SERVICE BULLETIN

APPLICABILITY: 2015-16MY STI Models

NUMBER: 07-105-16

SUBJECT: Change to Driver Controlled Center Differential (DCCD) Control Module

PRODUCTION CHANGE INFORMATION:

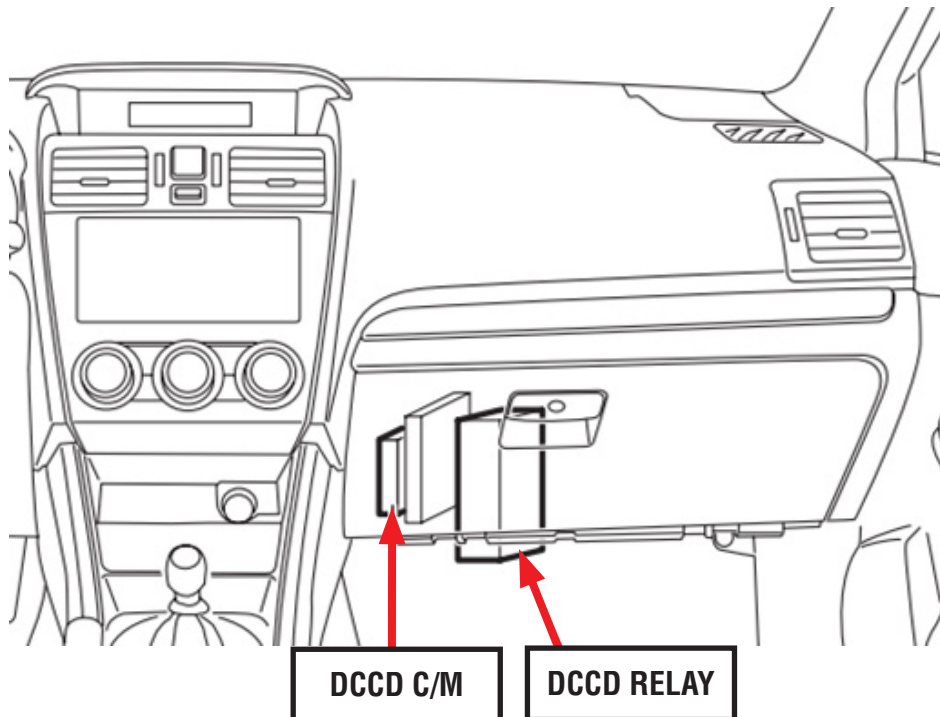
This bulletin announces availability of a new DCCD control module to address customer concerns of the manual setting being lost when turning off the ignition. If the operator adjusts the setting of the DCCD feature from the default, this new control module will retain that setting and eliminate the need to “reset” the DCCD whenever the ignition is turned off.

The new DCCD control modules were incorporated into production starting with VIN **G9818320**.

The new DCCD control module part number is **32520AA332**.
